THE DISTRICT BOARD OF TRUSTEES OF
PENSACOLA STATE COLLEGE, FLORIDA
1000 COLLEGE BOULEVARD
PENSACOLA, FL 32504-8998

BID 5-2013/2014

ADDENDUM #1
DOORS AND DOOR HARDWARE

PENSACOLA JUNIOR COLLEGE
 PENSACOLA CAMPUS
 SITE: NO. 1
 FACILITY NO. 4 FIRST FLOOR
 FACILITY NAME: LIBERAL ARTS

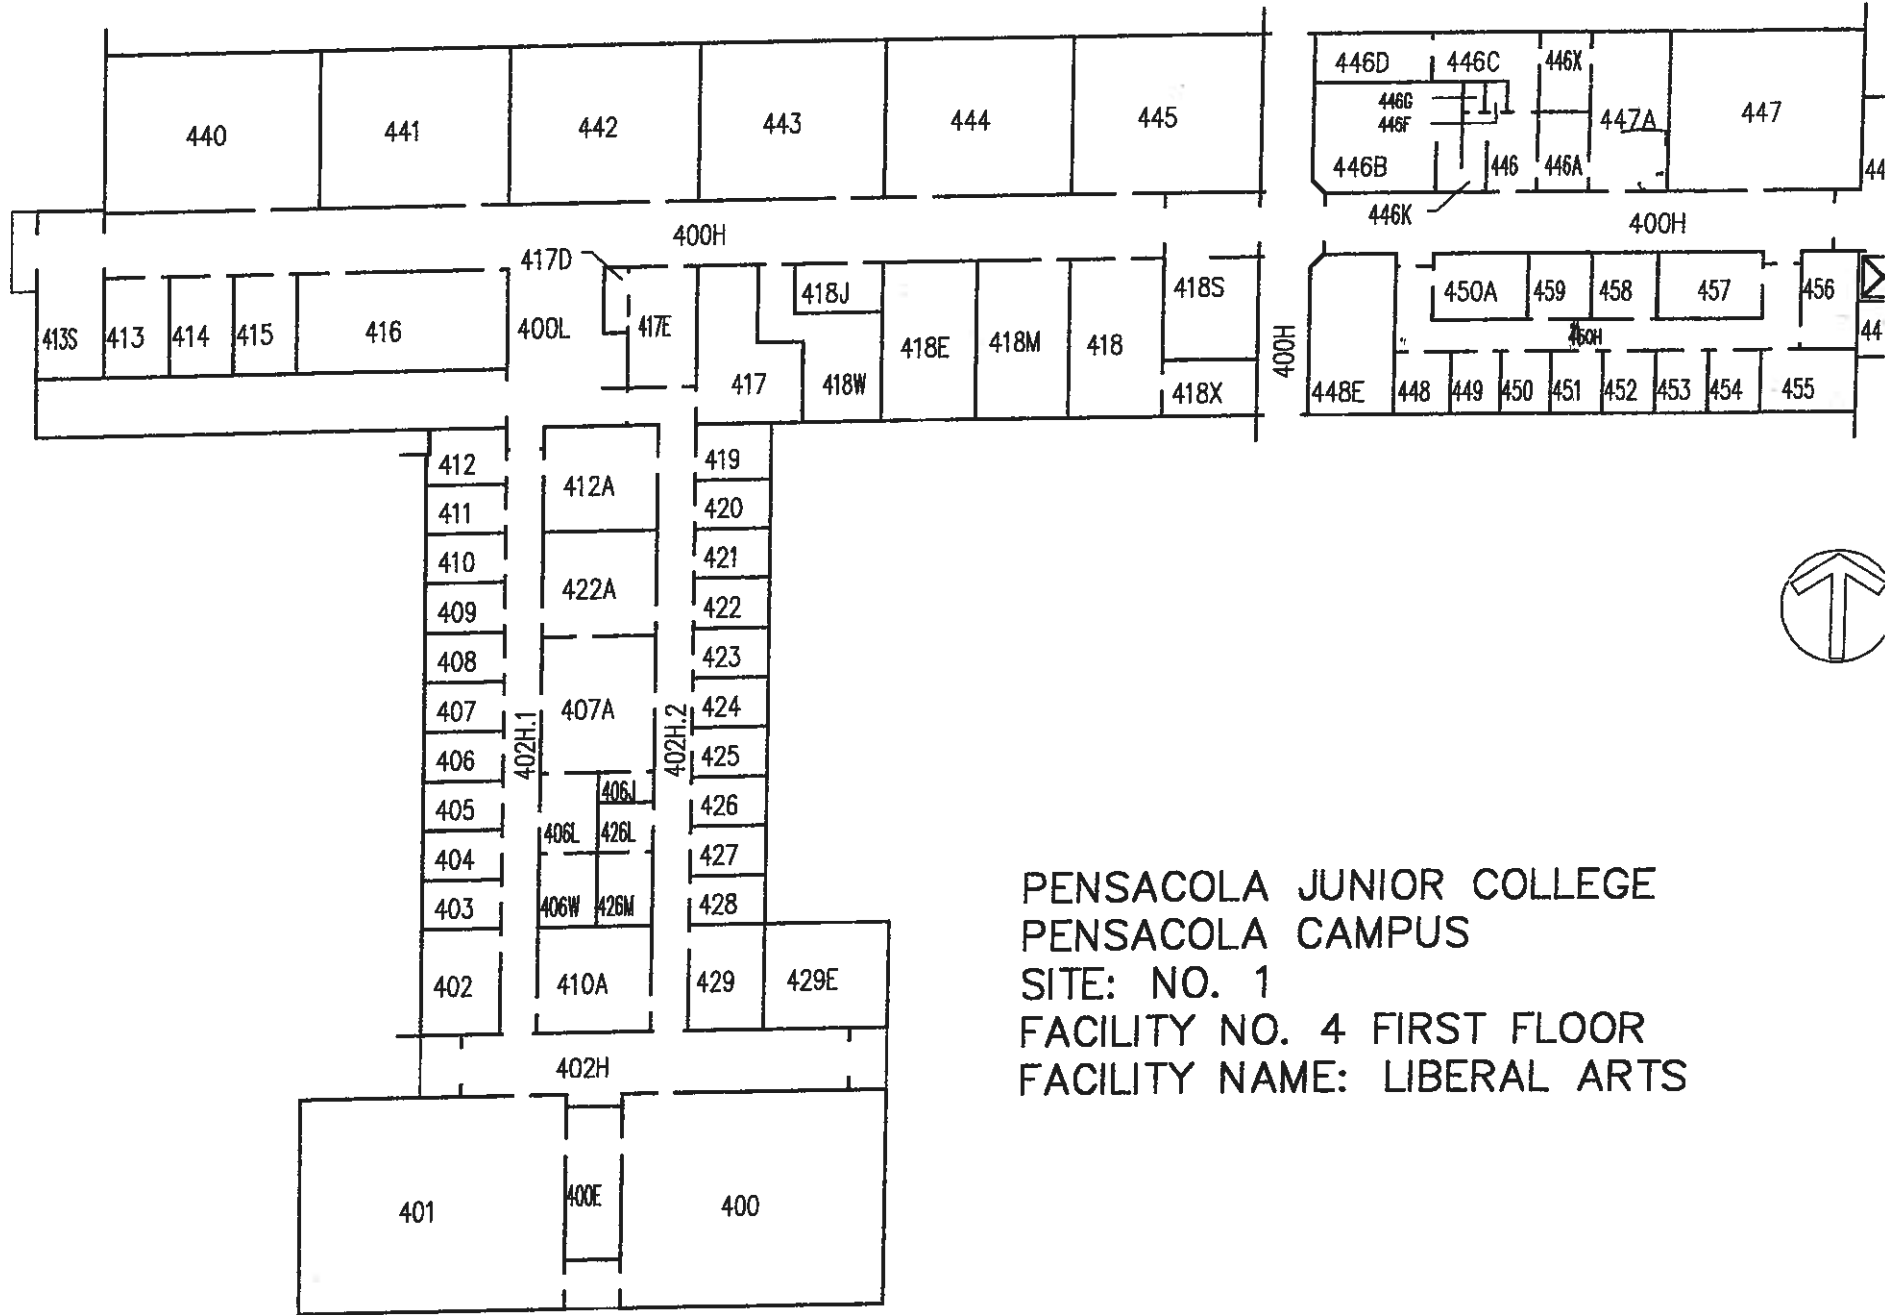
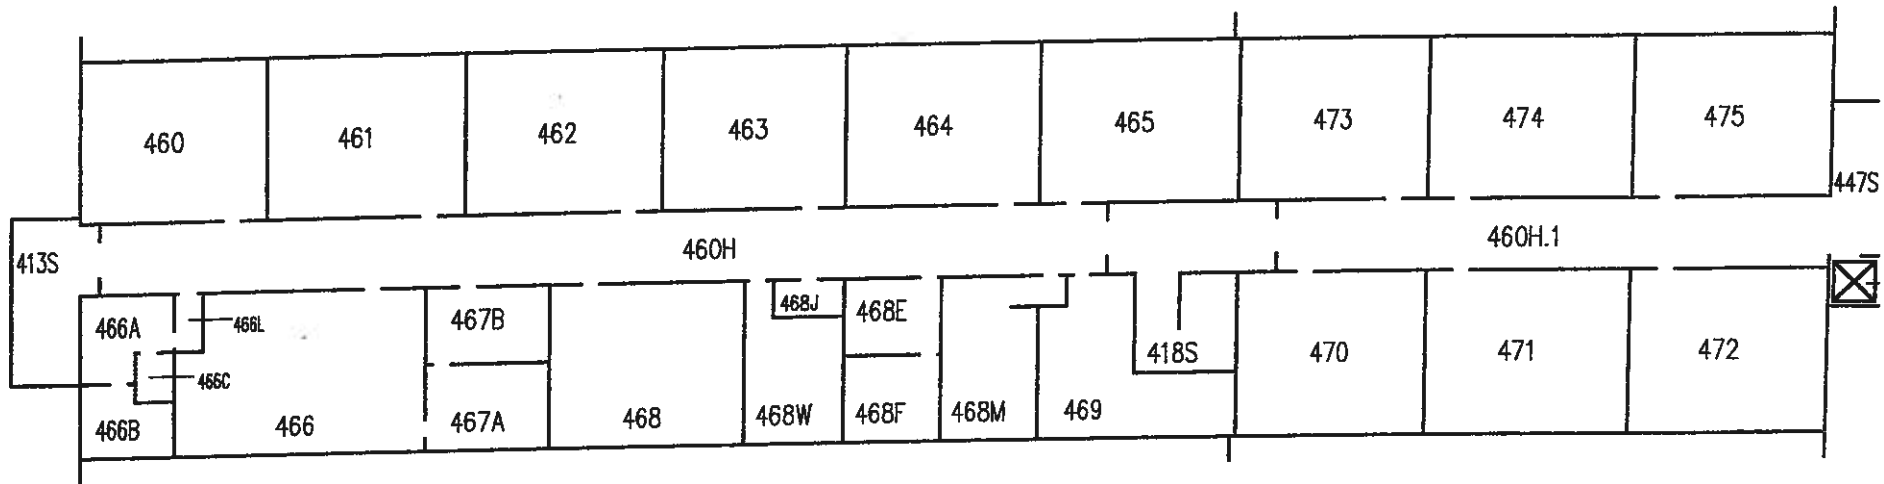
- 1) Question: Are there floor plans that identify the locations for the new doors?
Response: I have attached a pdf of the floor plans which may not be totally accurate. We are replacing every classroom door, every office door, and the corridor fire doors in the building.
